CALNE, PROPOSED WAITING RESTRICTIONS
RECOMMENDATIONS FOR AMENDMENTS TO PROPOSALS

Springfield Drive

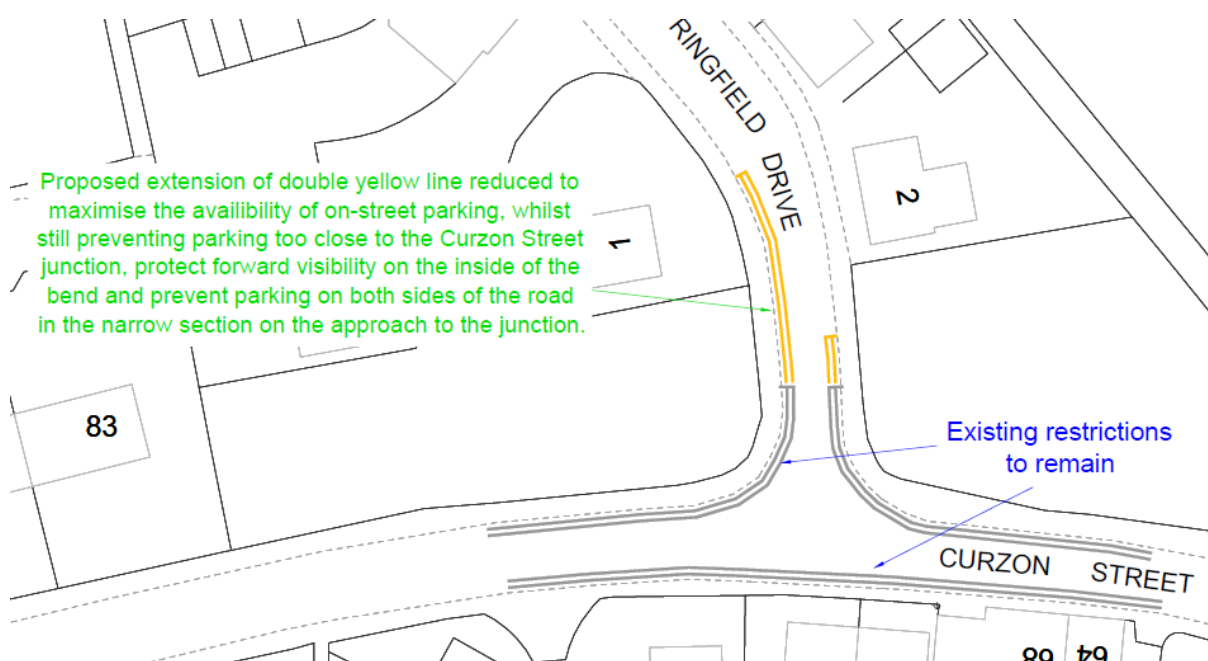
Further to the comments received during the consultation it is recommended to reduce the extent of the proposals. The proposal can be reduced to maximise the availability of on-street parking, whilst still preventing parking too close to the Curzon Street junction, protect forward visibility on the inside of the bend and prevent parking on both sides of the road in the narrow section on the approach to the junction.

Stockley Lane

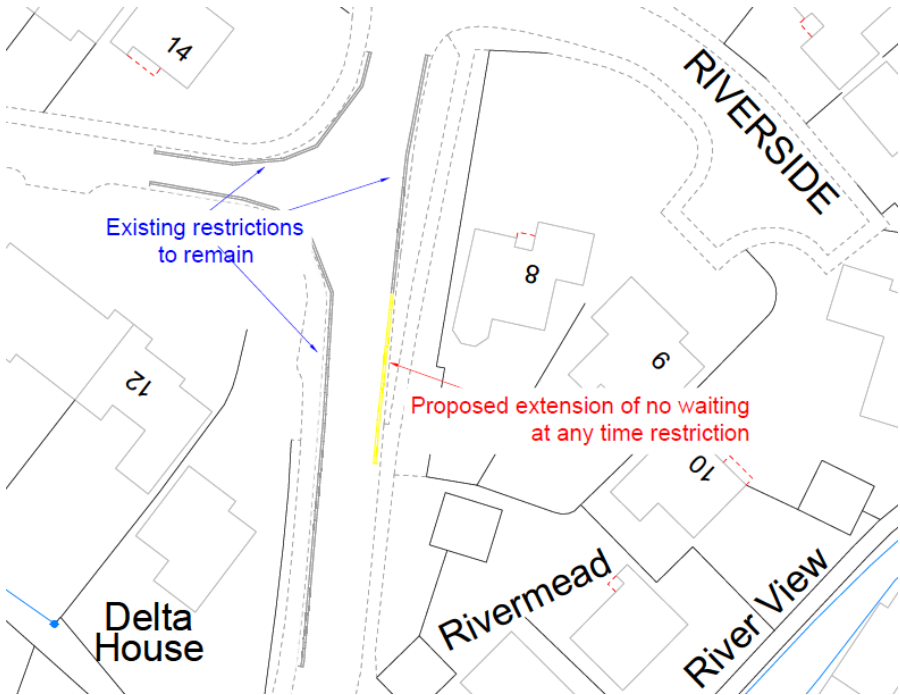
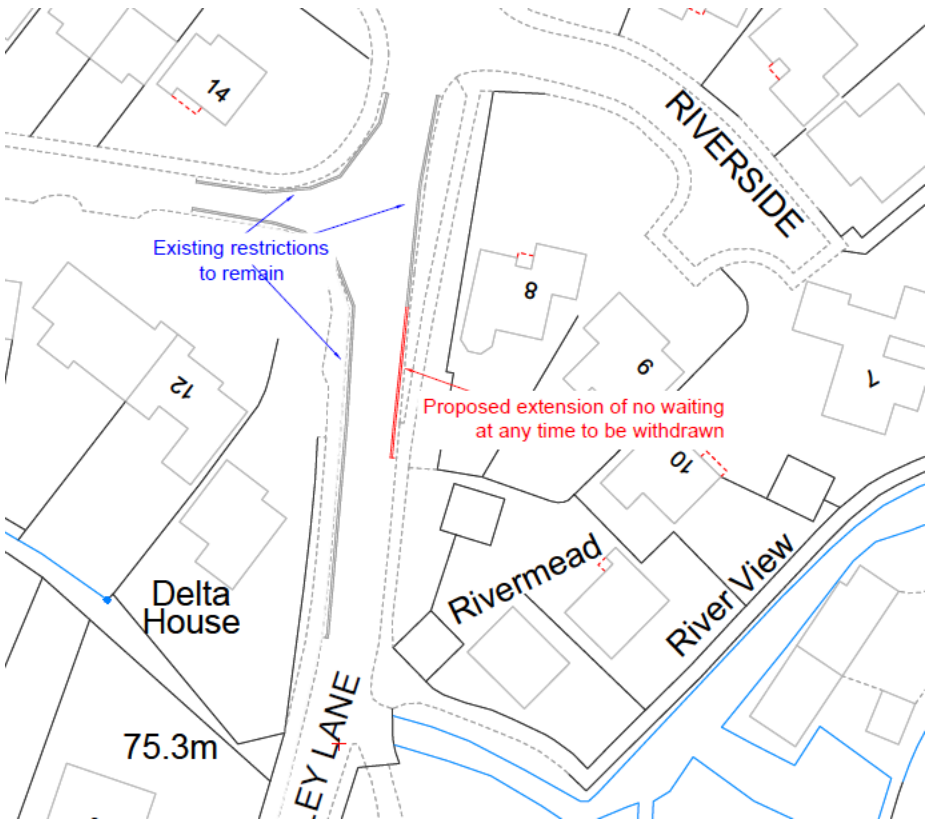
Recommendation following comments received is not to implement the proposed extension.
